**MM Docket 87-268
DTV Rulemaking**

Biennial Review

**Comments of
Hammett & Edison, Inc.
Consulting Engineers**

Comments of Hammett & Edison, Inc.

Elevation Pattern Plot for 3.6-Degree HPBW Antenna with 2° of EBT

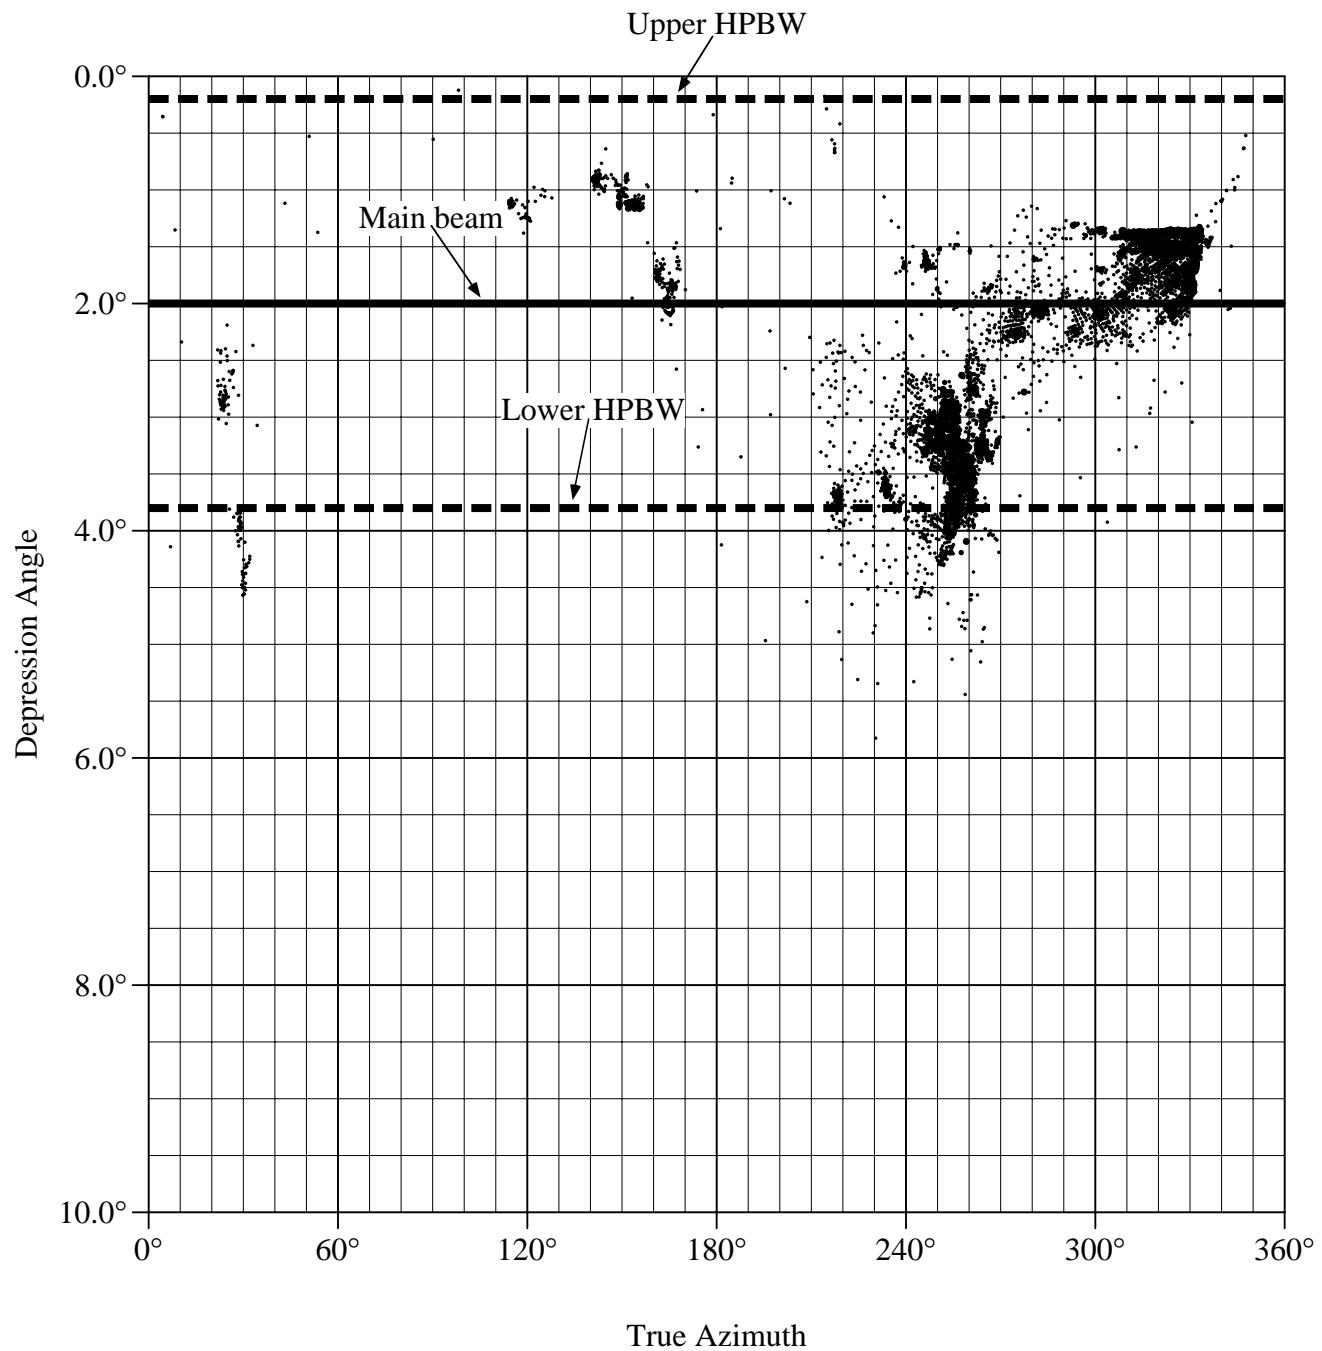
14. OET-69 provides generic UHF NTSC and DTV elevation patterns; these are shown in Figures 6A (for NTSC) and 6B (for DTV). Since these patterns were used to develop the DTV Table of Allotments and the “baseline” noise-limited, interference-free service for NTSC stations and DTV allotments, their use is necessary if current OET-69 interference studies are to replicate the FCC baseline populations. Of course, accurately replicating the FCC baseline populations is critical for determining whether a proposed facility will cause no more than *de minimus* new interference. There are two items to note regarding the OET-69 generic UHF elevation patterns: 1) Table 8 of OET-69 provides values only from 0.75° below the horizontal to 10° below the horizontal (and note that a positive beam tilt indicates an angle *below* the horizontal; that is, a beam tilt of 90° means straight down, and a beam tilt of -90° means straight up), and 2) an electrical beam tilt (“EBT”) of 0.75° for both the NTSC and for the DTV elevation patterns is presumed. Unfortunately, many NTSC stations on tall mountains have more than 0.75° EBT, and many employ a combination of electrical and mechanical beam tilts. Figures 7A and 7B demonstrate why good designs often employ both electrical and mechanical beam tilts. Figure 7A shows a transmitting antenna with a HPBW of 3.6° (corresponding to a Dielectric TFU-18GTH antenna) and with 2° of electrical beam tilt. The site is for a DTV station in the California Central Valley, on a 1,036-meter AMSL mountain approximately 48 kilometers east of the station’s principal community, which has an elevation of about 91 meters AMSL. It can be seen from Figure 7A that 2° of EBT would provide reasonably good coverage of the population distribution (and also that the 0.75° of

Elevation Pattern Plot for 3.6-Degree HPBW Antenna with 2° of EBT
Plus 1° MBT Toward 250°T

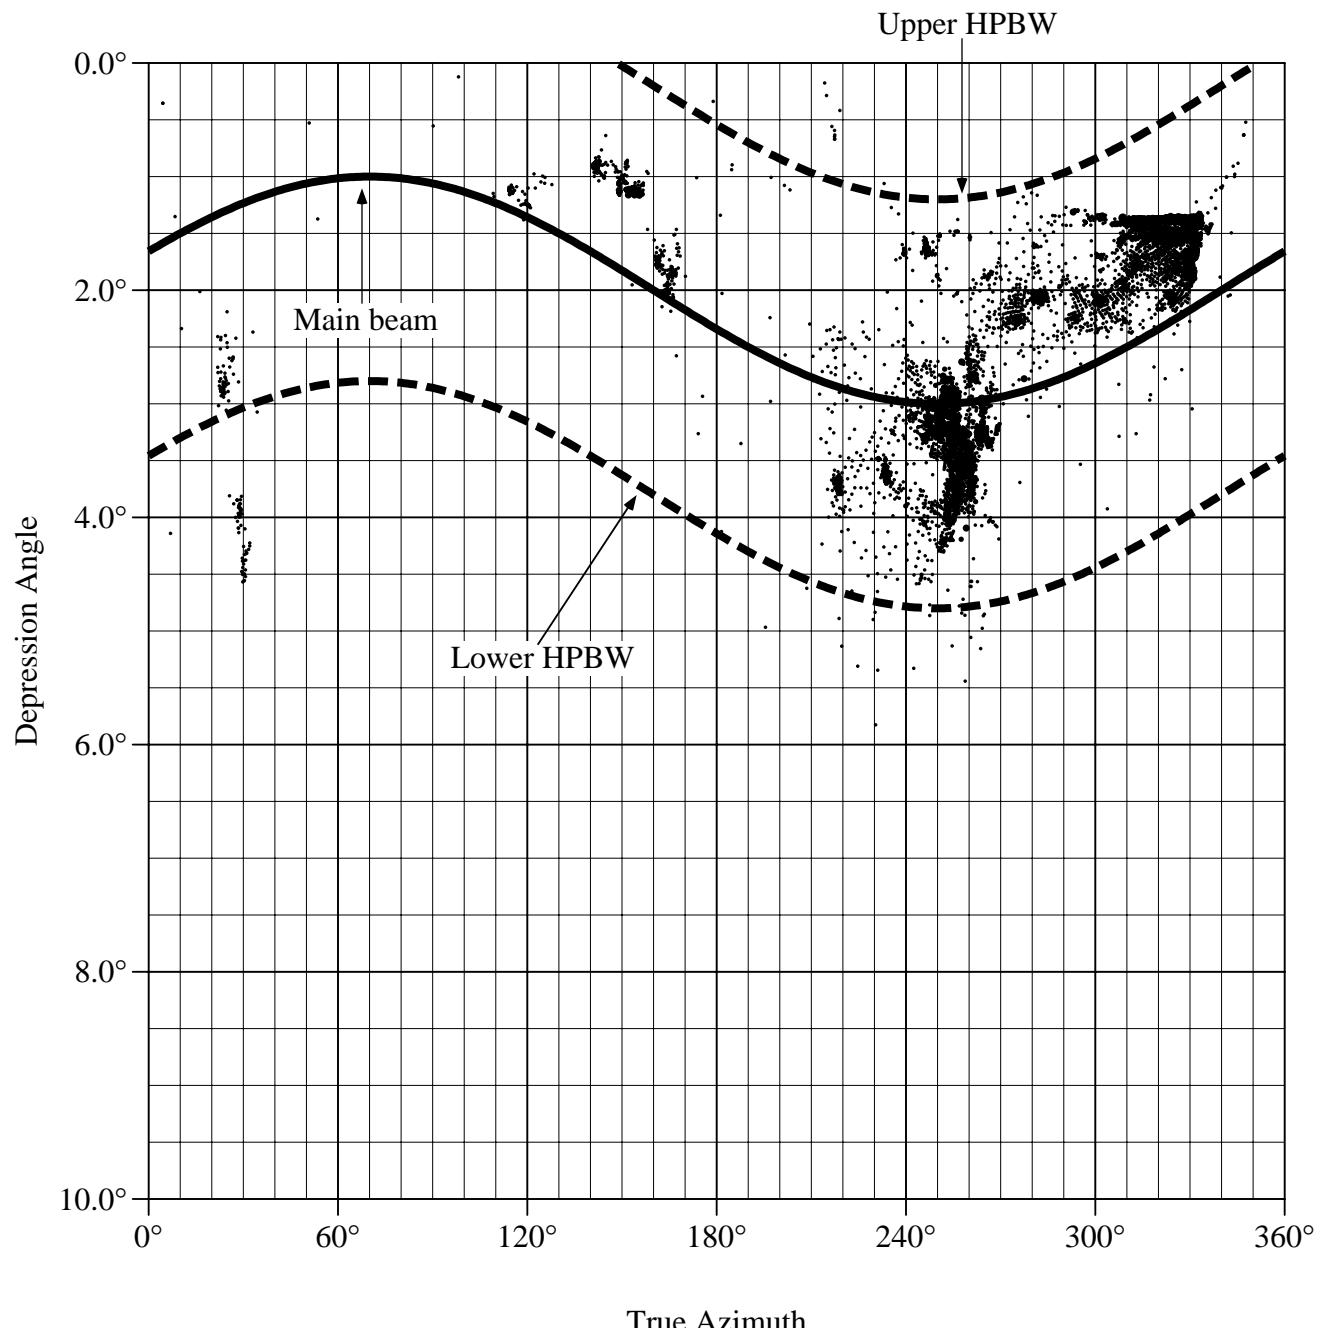
EBT presumed by OET-69 would not; indeed, an EBT of only 0.75° would result in most of the station's power being radiated hundreds to thousands of feet over the heads of potential viewers). However, Figure 7B, which adds 1° of mechanical beam tilt ("MBT") toward 250°T , the direction to the major population center, will result in almost a doubling of the ERP toward that population center, with no increase in transmitter power output. The mechanical beam tilt also improves coverage to population centers at 120°T , 150°T , and 165°T from the transmitter site.

**Comparison of Main-Beam and Horizontal Plane Azimuth Patterns
for Station with 2° EBT Plus 1° MBT at 250°T
- Relative Field -**

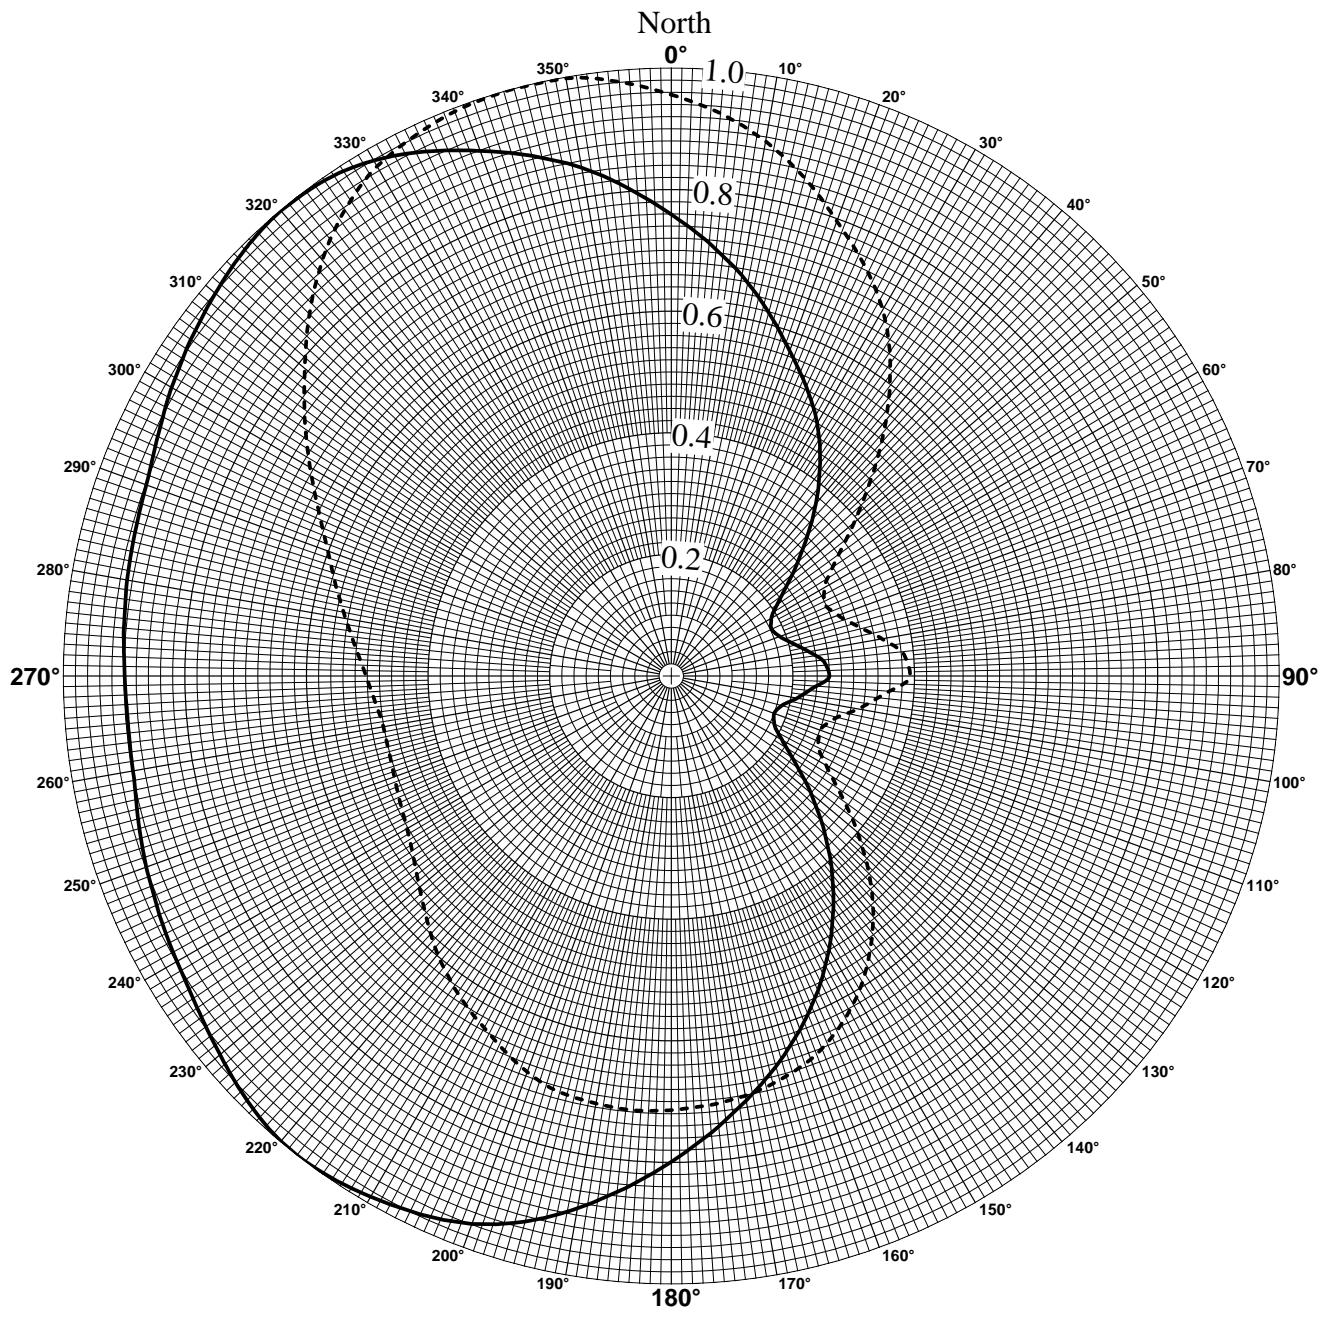
15. However, the inclusion of MBT means that the main beam and horizontal plane azimuth patterns are no longer the same, as shown in the attached Figure 8A; the solid line is the main-beam azimuth pattern (corresponding to the Dielectric TLP-M pattern at 270°T) while the dashed line is the horizontal plane azimuth pattern. Even greater departures are possible; for example, Figure 8B shows the main-beam versus horizontal plane patterns for a Mt. Wilson UHF station with 1.6° of EBT and 0.6° of MBT toward 225°T . The main-beam pattern is a Dielectric S180 at 172°T , whereas the horizontal plane pattern has its maximum at 92°T . The horizontal plane pattern is important because it is that pattern that Section 73.685(e)(2) of the NTSC Rules, and Section 73.625(c)(3)(ii) of the DTV Rules, states must be provided in applications that propose a directional transmitting antenna. Further, the Rule states, "Where mechanical beam tilt is intended, the amount of tilt in degrees of the antenna vertical axis and the orientation of the downward tilt with respect to true North must be specified, and the horizontal plane pattern must reflect the use of mechanical beam tilt." Thus, both the NTSC and DTV Rules are clear that 1) it is the horizontal plane azimuth pattern and not the main-beam azimuth pattern that is to be used and 2) that the horizontal plane azimuth pattern must reflect the effect of MBT when used. In other words, this is not an ambiguously worded rule, requiring interpretation by FCC staff. Finally, it should be noted that the magnitude of the effect of MBT on the main-beam pattern depends on 1) the elevation pattern shape; 2) the amount of EBT; 3) the amount of MBT; and 4) the direction of the MBT.

Different Consumer Receive Antenna Patterns, as Assumed
by FCC "Replication" Program to Develop DTV Allotments
- Low-Band VHF -

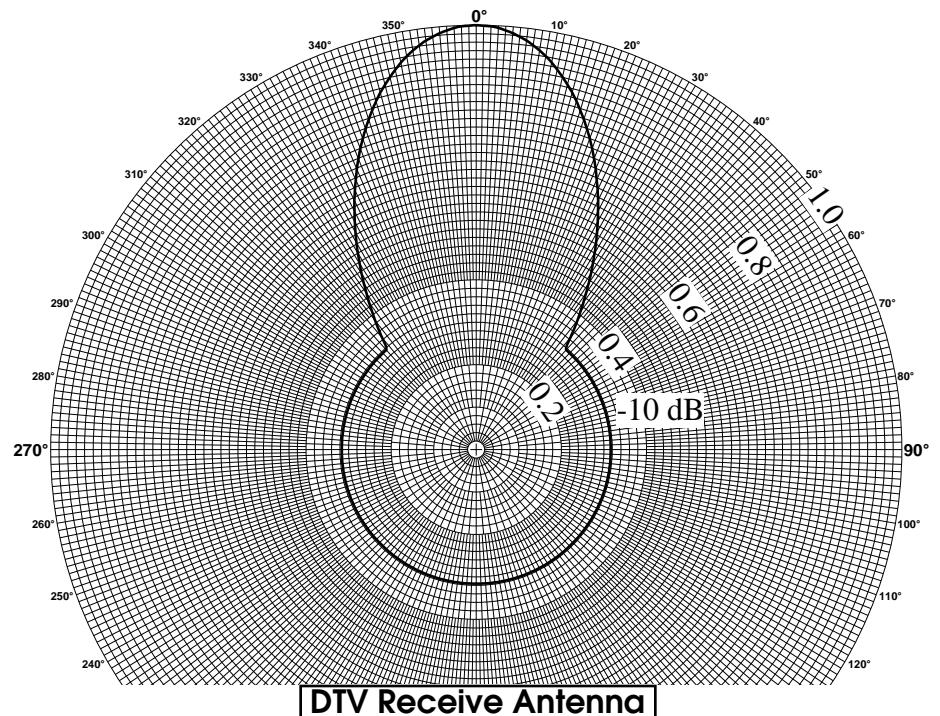
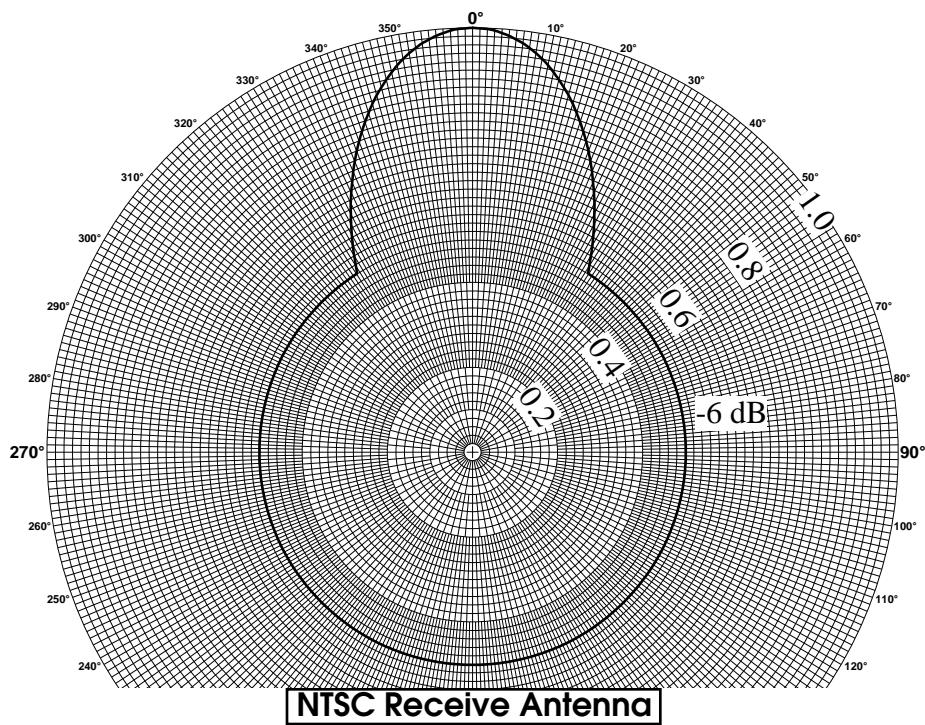
20. As shown by Figures 10A, 10B, and 10C, examination of the FCC source code reveals that the FCC assumed different receiving antenna performance for VHF low-band, VHF high-band, and UHF receiving antennas depending on whether the antenna is receiving an NTSC or DTV signal.⁵ This is questionable, as clearly few viewers will erect separate receiving antennas for NTSC and for DTV; rather, most viewers will use a single antenna to receive both signals. The off-axis (front-to-back ratio) of the presumed DTV receiving antennas are higher than the corresponding NTSC receiving antenna, as follows:

<u>low-band VHF</u>	<u>high-band VHF</u>	<u>UHF</u>
rejection improvement compared to NTSC receive antenna:	4 dB	6 dB	8 dB

21. The only apparent explanation for the different (and better performing) receiving antennas assumed for DTV is that this was the only way the Commission could come up with a DTV Table of Allotments that would meet desired replication levels for the existing coverage of NTSC stations. Now that a finalized DTV Table of Allotments exists, it would be appropriate for the Commission to specify just one receiving antenna pattern for low-band VHF, one pattern for high-band VHF, and one for UHF, when making OET-69 interference studies.

Group Delay Measurements on
New NTSC Transmitter with N+1 DTV Channel
Common Transmission Line and Antenna

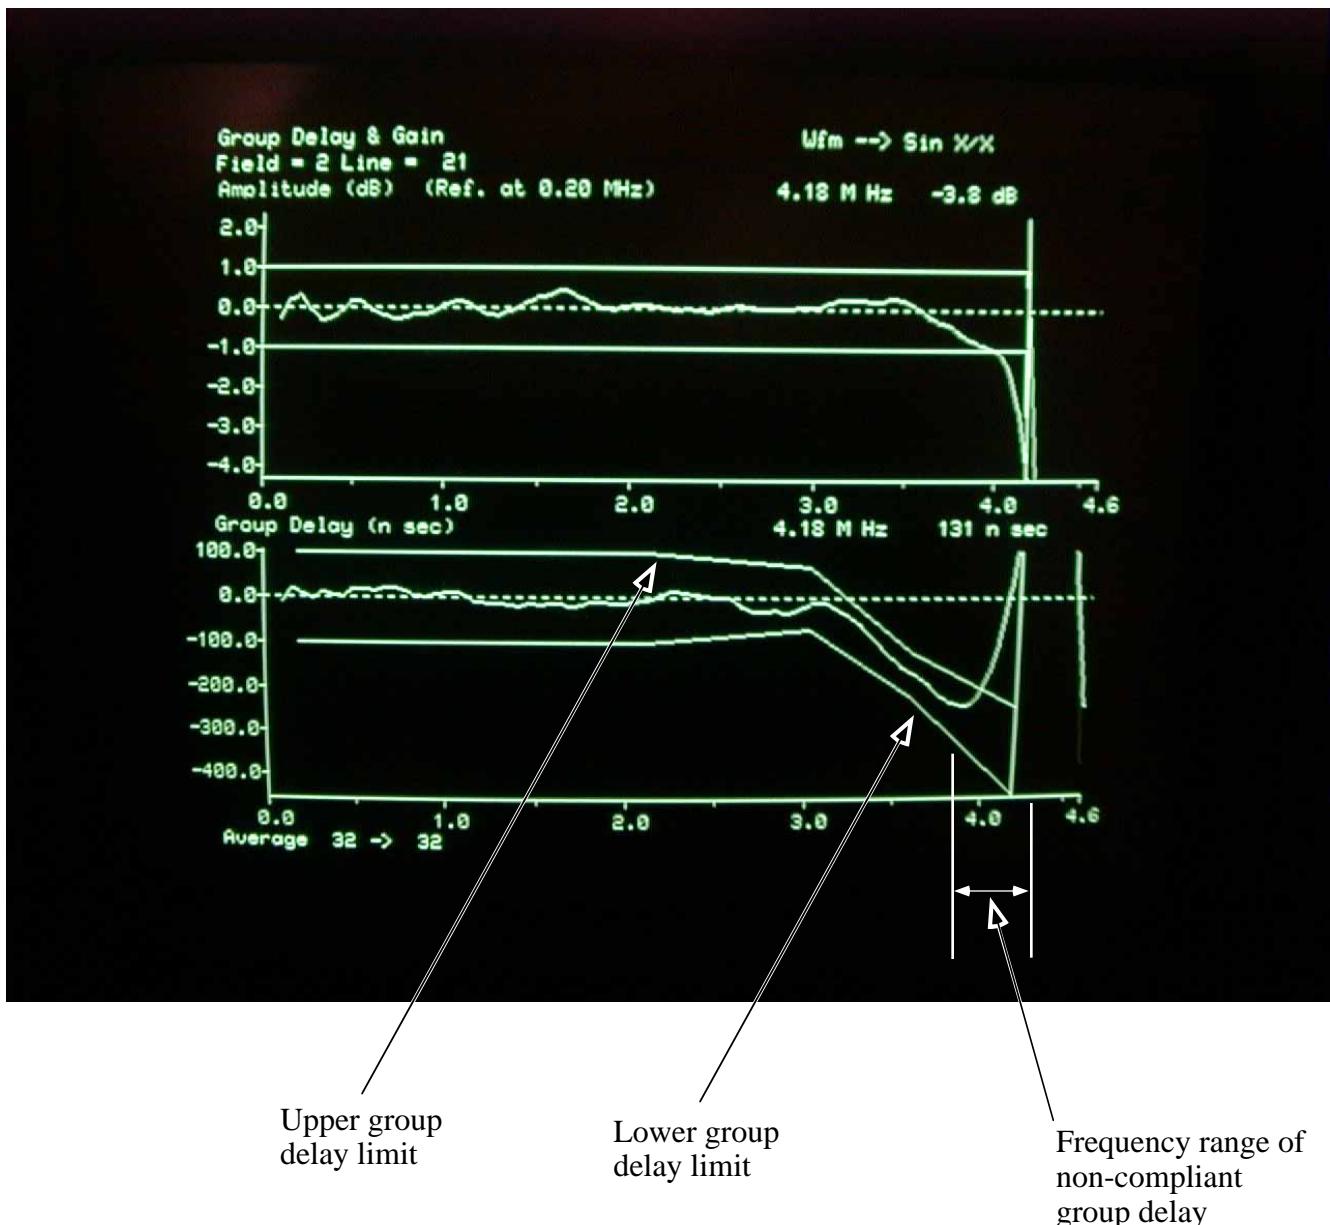
that is, from approximately 3.9 to 4.2 MHz above the visual carrier. The attached Figure 11 documents the problem.

23. Group delay errors caused by an N+1 combiner may be capable of being canceled out by introducing a reciprocal group delay error in the NTSC exciter; however, this may require a custom surface acoustic wave (“SAW”) filter, which can require several weeks, if not months, to obtain. A waiver to allow temporary operation with out-of-tolerance group delay has already been obtained for an N+1 situation for a West Coast NTSC station, and we note that an out-of-tolerance group delay characteristic has no out-of-band interference potential to other stations or services. Rather, its effect is confined entirely to the transmitting station’s picture quality, and even then the impact is minimal on consumer-grade television receivers so long as the group delay characteristics between zero and 3.9 MHz of the visual carrier are within tolerance.

24. Rather than require many individual waiver requests for operation with group delay characteristics not entirely meeting Section 73.687(a)(3) of the FCC Rules, we suggest that the Commission consider issuing a public notice announcing a “blanket waiver,” automatically applying to NTSC/DTV stations with an N+1 channel relationship and using a common transmission line/antenna. We recommend that this blanket waiver allow departure from the required group delay characteristics for video frequencies between 3.9 and 4.2 MHz above the visual carrier for up to a six-month period, if documenting entries are made in the station log.
